November 21, 2016

Re: ENERGY STAR Program Requirements
Product Specification for Clothes Washers, Eligibility Criteria, Draft 2, Version 8.0

Figure 1: Soil Lot Within Machine Type

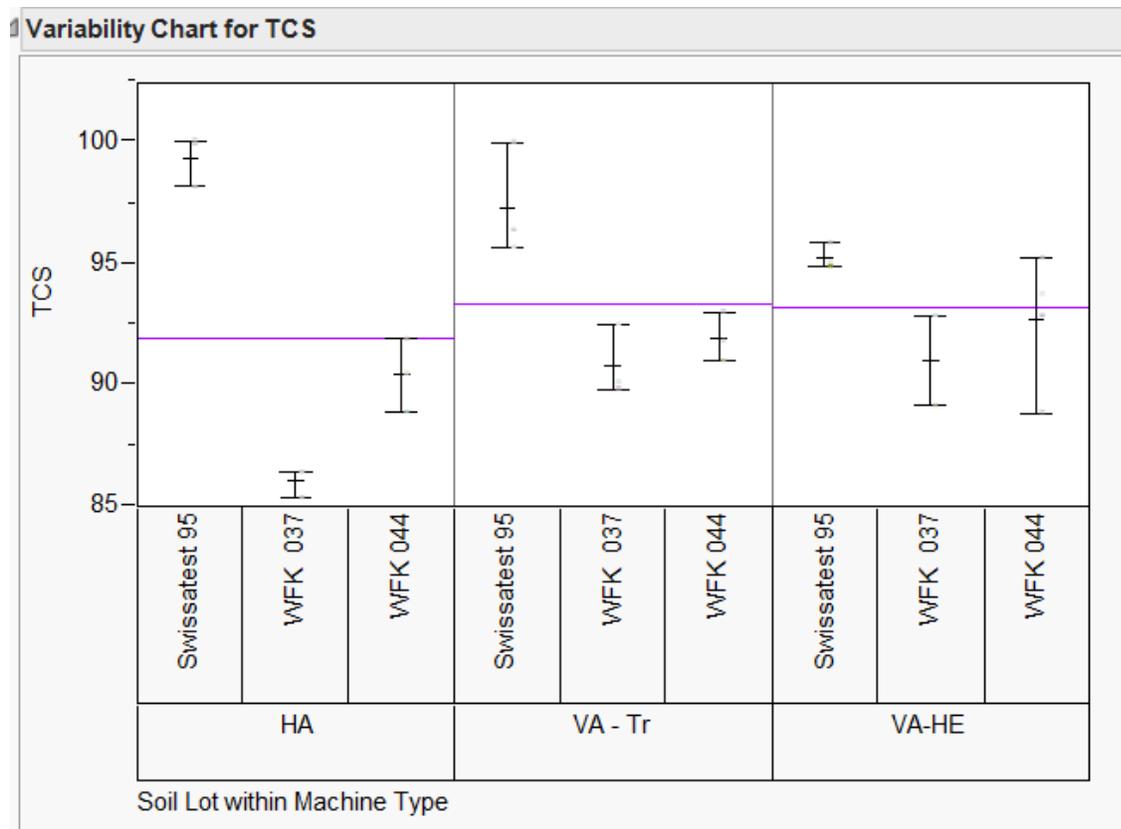
As part of an ongoing effort related to HRF-1-2013, AHAM has conducted some repeatability testing. That testing revealed that variation is too large for use in any kind of reporting or verification plan. The cleaning score results were:

Significantly, the soil/stain strips performed differently. Strips from Swisstatest consistently scored higher than strips from WFK as shown below in Figure 1.

Figure 2: Detergent Batch Within Machine Type

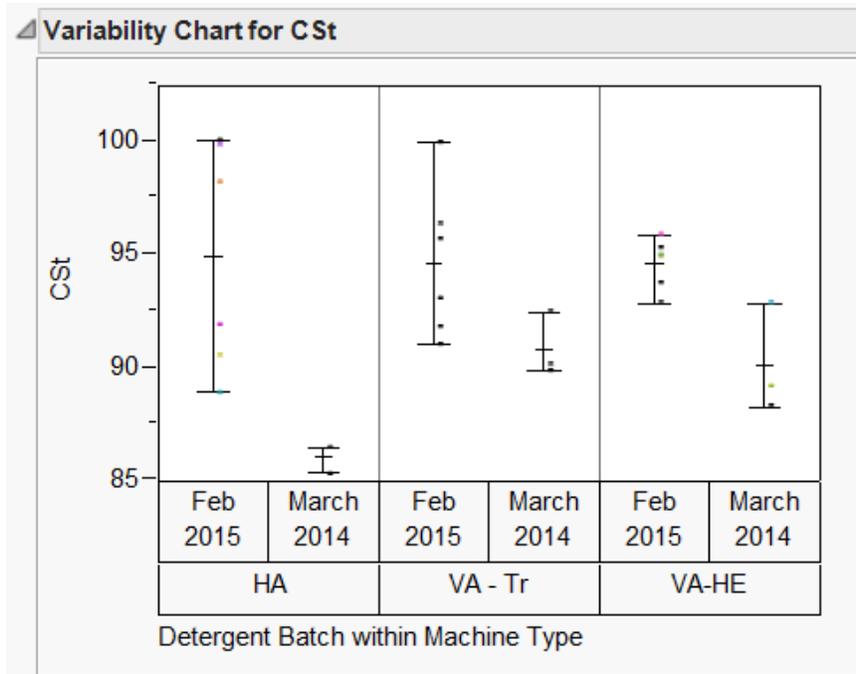
The detergent also showed similar results—the February 2015 detergent batch consistently resulted in higher scores and showed more variation overall than the March 2014 lot as shown in Figure 2.
